Serial No. : 10/616,495 Filed : July 9, 2003 Page : 12 of 17

<u>REMARKS</u>

Annotated Sheet 1 of 1 Appln No.: 10/616,495 Applicant(s): Jordan T. Bourilkov et al. FUEL CARTRIDGE INTERCONNECT FOR PORTABLE FUEL CELLS

Patent Application Publication Apr. 29, 2004 Sheet 2 of 6 US 2004/0081884 A1

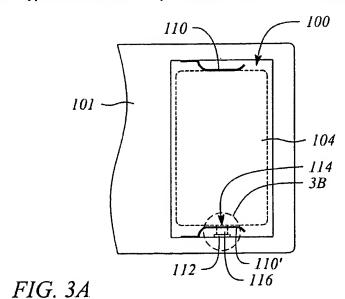
Bean et al. in Figures 2 and 3 A disclose mating fitting on a member that a pair of spaced battery terminals and an aperture to receive an ingress port on a fuel cell interconnect.

Applicant contends that the combination of Bean with Sainsbury fails to suggest the features of claim 2. Bean does not teach "the mating fittings on the member include a pair of spaced battery terminals and an aperture to receive an ingress port on a fuel cell interconnect," as the examiner argues. Rather, Bean discloses the arrangement shown in FIG. 3A reproduced below:

In this arrangement, the compartment interchangeably holds either a battery or a fuel cartridge. However, Bean has only contemplated a compartment to receive conventional cells in which anode and cathode are on opposite ends of the battery. In contrast, Applicant's mating

FIG. 1

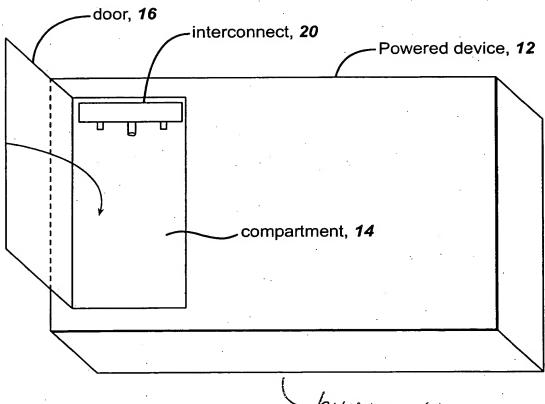
In Figure 1, reference designation "housing, 11" was added.

The examiner also objected to the drawings as failing to comply with 37 CFR 1.84(p)(5) because they do not include "reference characters "11", as mentioned on page 3, line 18; "137", as mentioned on page 7, line 24; reference characters mentioned on page 13, line 10 through page 14, line 16."

Applicant has corrected FIG. 1 to include 11; 137 is not findable in the specification; and has amended the specification to correct the reference characters mentioned on page 13, line 10 through page 14, line 16 to be consistent with those shown in FIGS. 9 and 10.

- housing, 11
